# DESIGN METHOD FOR STABILIZATION OF SLOPES WITH PILES<sup>a</sup>

Discussion by Robert W. Day,<sup>4</sup> Fellow, ASCE

## Discussion by T. S. Hull<sup>5</sup> and H. G. Poulos,<sup>6</sup> Fellow, ASCE

### Closure by S. Hassiotis,<sup>7</sup> J. L. Chameau,<sup>8</sup> and N. Gunaratne<sup>9</sup>

FIG. 13. Design of Pier Wall for Wedge Slope Failure

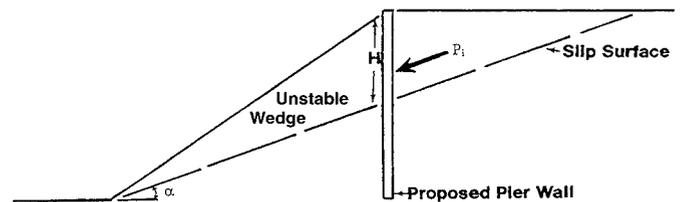
Fig. 13 shows an unstable slope having a planar slip surface inclined at an angle ( $\alpha$ ) to the horizontal. This mode of failure is similar to the Portuguese Bend landslide (Ehlig 1986, 1992) and the eventual wedge failure of the Desert View Drive fill embankment (Day 1996). The shear strength of the slip surface can be defined by the effective friction angle ( $\phi'$ ) and the effective cohesion ( $c'$ ). The factor of safety (FS) of the slope with the pier wall is derived by summing forces parallel to the slip surface and is written as

The only unknown in (15) is  $P_i$  (inclined pier wall force; Fig. 13). The following equation can be used to calculate the lateral design force ( $P_L$ ) for each pier having an on-center spacing of  $S$ :

The location of the lateral design force ( $P_L$ ) is ordinarily assumed to be at a distance of  $1/3 H$  above the slip surface, where  $H$  is defined in Fig. 13. The lateral design force ( $P_L$ ) would be resisted by passive pressure exerted on that portion of the pier below the slip surface.

FIG. 16. Bishop Modified Analysis of Slope with Piles

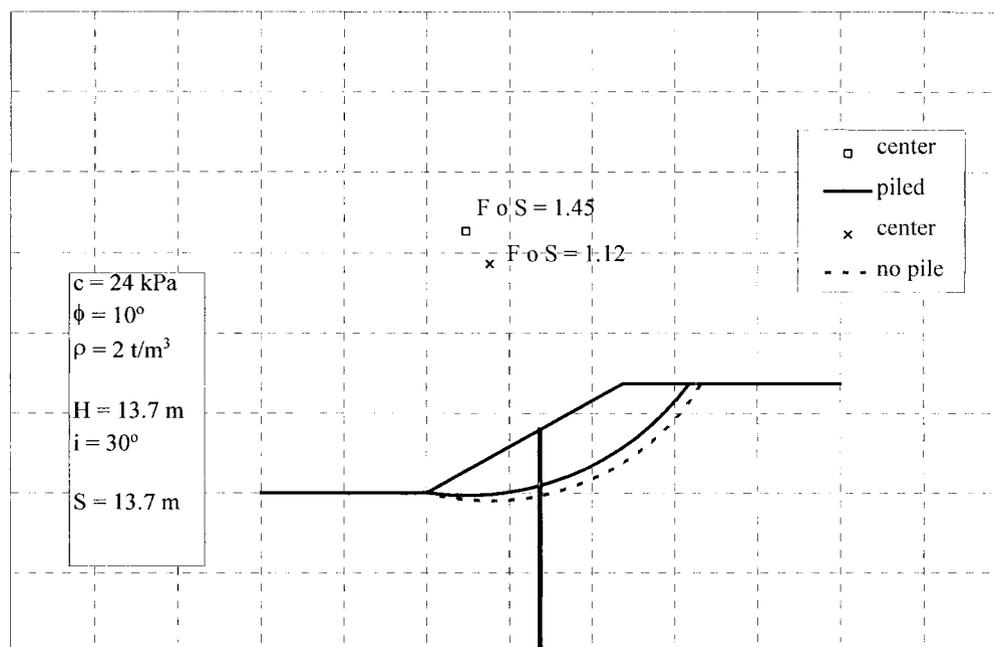
Fig. 16 shows the slope with the centers of the critical circles for a piled slope and a slope with no piles. The factor of safety without piles is found to be 1.12, and the critical circle from the Bishop analysis essentially agrees with that from the authors' analysis. The introduction of piles raises the factor of safety to 1.45 in the discussers' analysis, whereas the authors' analysis predicts a value of 1.82 and the two circles are now different. These two answers are sufficiently different to raise considerable concern over the validity of the authors' less con-

servative answer. In order to make a comparison with the authors' analysis, the possibility of structural failure of the pile has not been considered by the discussers. However, our analysis indicates that the maximum bending moment sustained by a row of 400 mm diameter concrete piles at a spacing of 1 m is in excess of 2.0 MNm, which far exceeds the structural capacity of the piles.

Some discussion by the authors of the validity of the comparison between the two factors of safety, and the question of the structural capacity of the piles, would be appreciated.

FIG. 17. Forces on Slope Reinforced with Piles

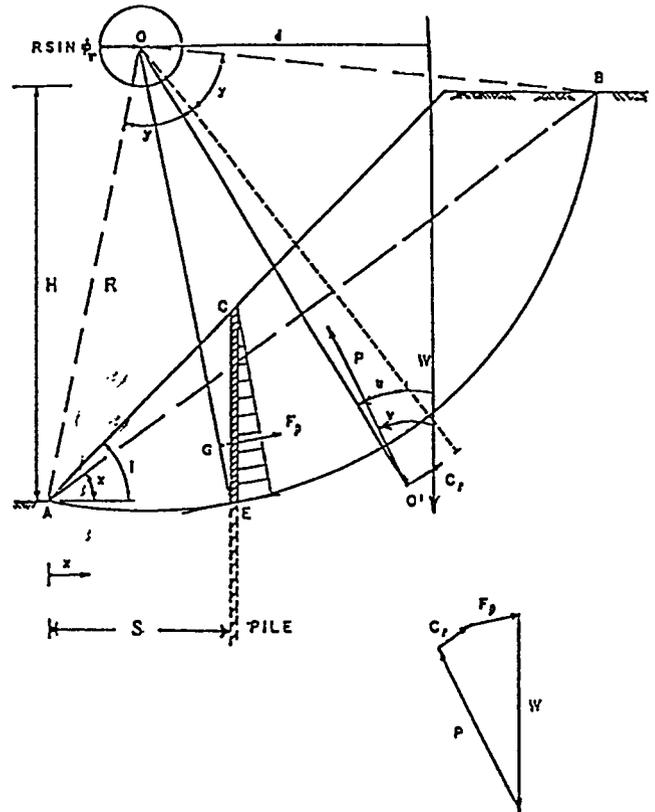
The writers thank the discussers for their valuable comments. Regarding the comments on the moment equilibrium, the writers wish to point out that in deriving (7) and (8), the moment equilibrium was considered as well. However, the writers understand the concern in light of the graphical error in Fig. 3, where the three forces  $P$ ,  $C_r$ , and  $W$  are mistakenly drawn as being concurrent, as in the case of unpiled slopes. Accordingly, the corrected free-body diagram is provided in Fig. 17. It must be reiterated that the concurrency was by no means assumed in the derivation of the above equations.

**Errata.** Mistakes were made in processing and plotting the limit equilibrium solutions for cohesive slopes. The corrected versions of Figs. 5–9 are given here.

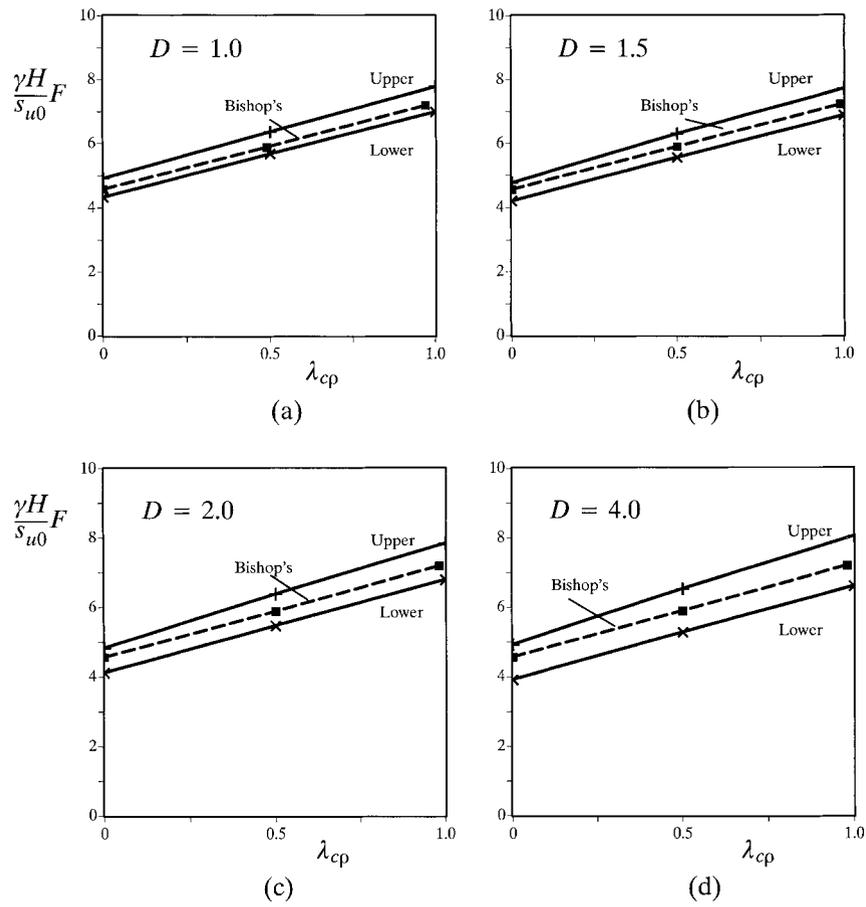
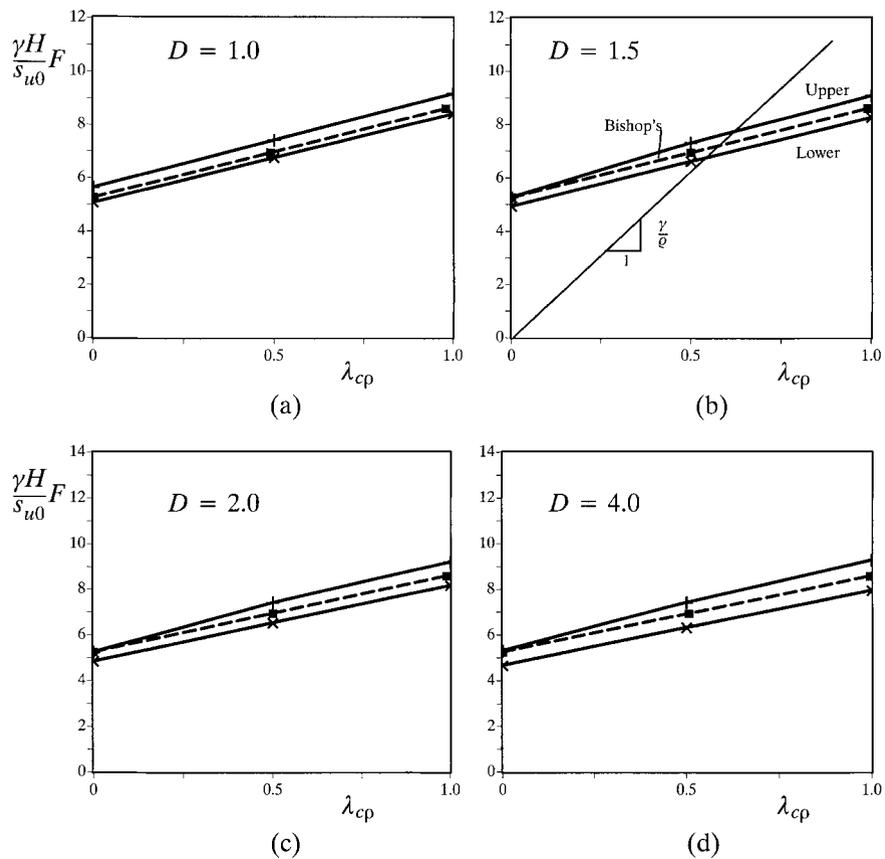
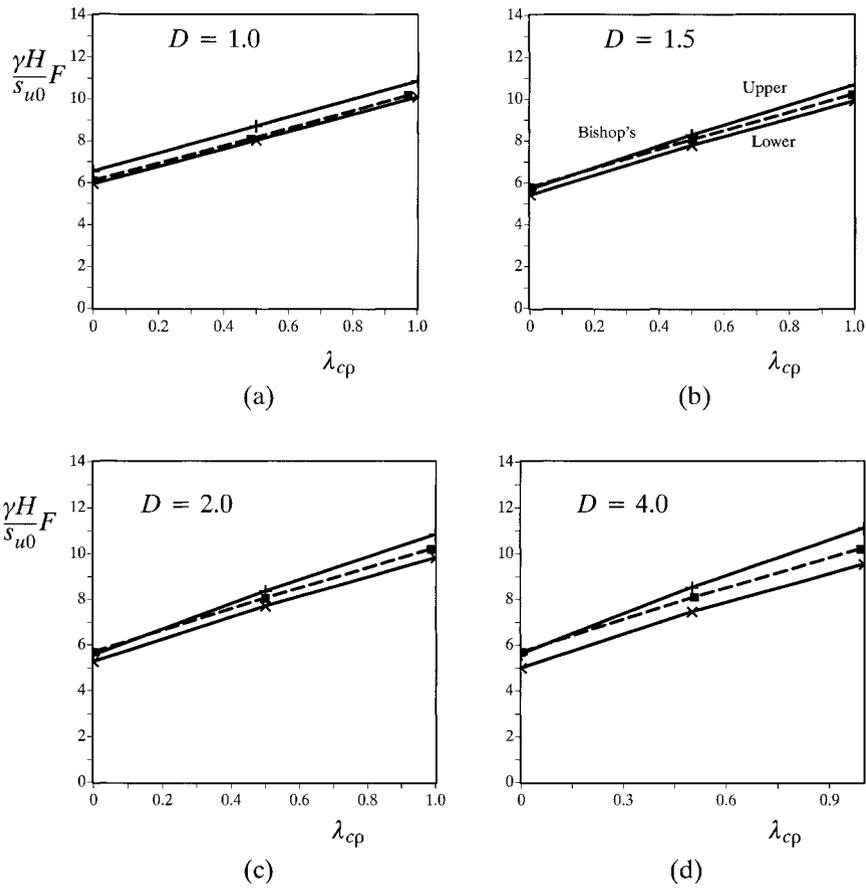
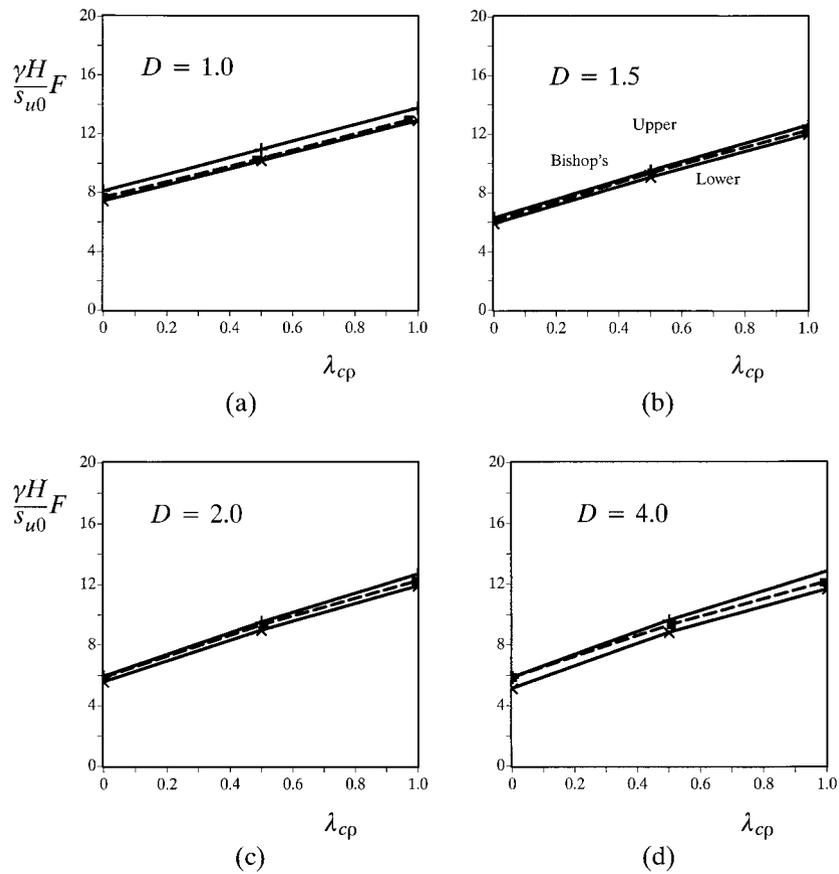
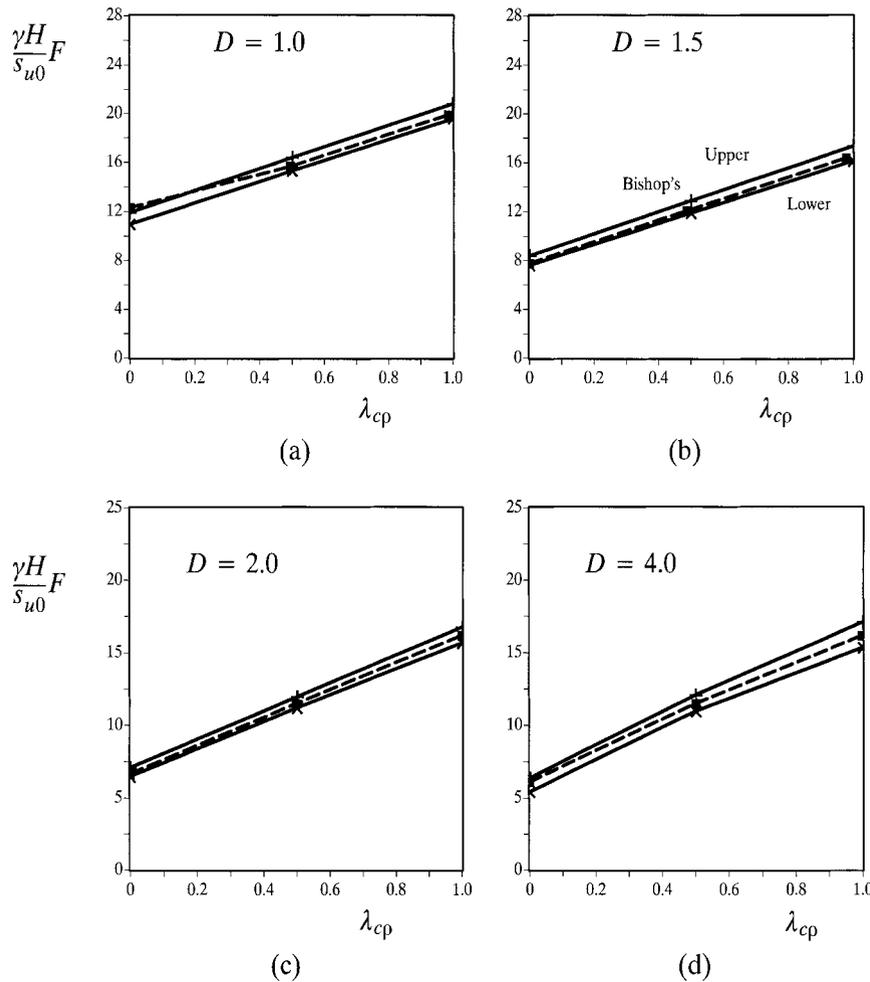
3. With respect to the results presented in Figs. 5–9, it should be pointed out that there was a mistake made in the paper in processing and plotting the limit equilibrium solutions. The corrected versions of these figures are given in the Errata at the end of this closure. The issues raised in item 3 of the discussion would largely disappear after considering the corrected version of Figs. 5–9. As

shown in the corrected Figs. 5–9, the limit equilibrium results agree well with the numerical lower and upper bound solutions for all slope angles and depth factors considered. While higher than the numerical lower bounds, the limit equilibrium solutions are slightly lower than the numerical upper bounds. This is in agreement with the earlier results presented in Chen and Liu (1990), who find that for cohesive slopes their upper bounds are also slightly higher than the limit equilibrium results.
